CITY OF WESTMINSTER			
PLANNING APPLICATIONS COMMITTEE	Date 2 February 2016	Classification For General Release	
Addendum Report of Director of Planning		Ward(s) involved Hyde Park	
Subject of Report	8 Connaught Square, London, W2 2HG,		
Proposal	Use as a single dwellinghouse, excavation of basement floor below lower ground floor of main house and rear extensions, infill extension at lower ground level within rear lightwell, installation of mechanical plant on rear first floor level terrace and associated internal and external alterations.		
Agent	Obsidian London Ltd		
On behalf of	Mr Mubashir Mukadam		
Registered Number	14/11257/FULL & 14/11258/LBC	Date amended/ completed	10 April 2015
Date Application Received	12 November 2014		
Historic Building Grade	II		
Conservation Area	Bayswater

DRAFT DECISION LETTER – 14/11257/FULL

DRAFT DECISION LETTER – 14/11258/LBC

PROPOSED NEW BASEMENT

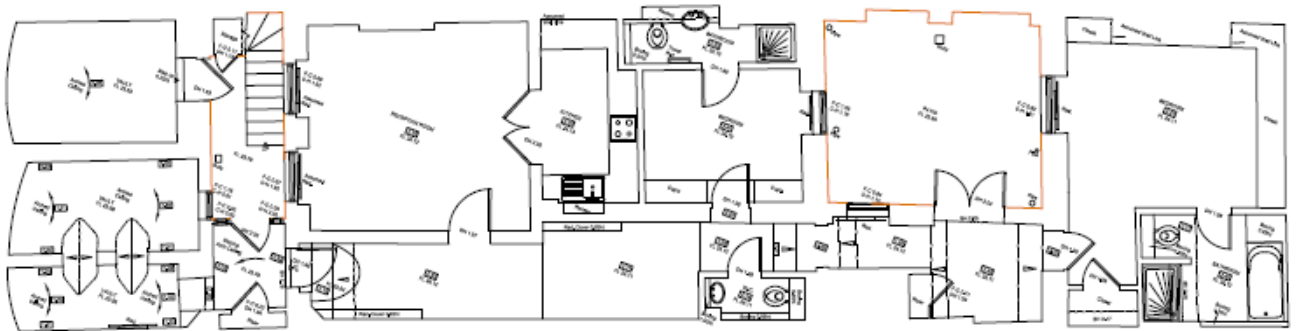
'In the case of the application property, the plan form and hierarchy of spaces are considered to be contributory factors to its significance and the introduction of a basement storey of the size and volume proposed would have an adverse impact on this significance. The degree of harm caused is assessed to be less than substantial and as such the NPPF indicates that in such circumstances this harm should be weighed against the public benefits of the proposal. In this case there are no public benefits delivered by the proposal and as such the harm outweighs the benefit. As special regard must be given to the desirability of preserving the building and any features of special architectural or historic interest which it possesses, it is therefore concluded that the proposed basement is unacceptable and is contrary to Policies S25 and S28 of the City Plan; DES 1 and DES 10 of the UDP; the guidance within the SPD 'Basement Development in Westminster' (2014) and the guidance in the SPG 'Repairs and Alterations to Listed Buildings' (1996). The proposal would also be contrary to national policy and guidance in the NPPF and the guidance of Historic England for alteration and extension of buildings of this period.

'Because the listed building has undergone a degree of change, with some modern additions and alterations, it is considered that there is some potential to extend at basement level, but that this extension should be confined to beyond the main rear wall line of the main house, effectively beneath the rear extensions. This would have the effect of reducing the scale and volume of the extension and also confine it to beneath the later parts of the site and thus minimising any impact on the historic plan form and spatial hierarchy of the building. This has been suggested to the applicant but they have not chosen to accept this suggested option.'

Following the committee meeting on 28 July 2015, the applicant was invited to again consider reducing the extent of the basement extension so that it is confined to below the rear of the site beyond the main rear wall line of the main house. However, the applicant has declined to reduce the size of the proposed basement floor and the proposed basement remains below the main house and its rear extensions and rear lightwell. In the absence of any amendment to the extent of the proposed basement, the harm to the listed building in terms of the erosion of its historic plan form and hierarchy of spaces would remain as set out in the preceding paragraphs and it is considered that this element of the scheme remains unacceptable.

- (a) Reduction in footprint and location of basement extension so that it is confined to below the later rear extensions and lightwell and not below the original building, with access within the rear additions.

- (b) Reduction of floor to ceiling height of basement so that it maintains the hierarchy of rooms within the building in terms of their volumetric proportions.
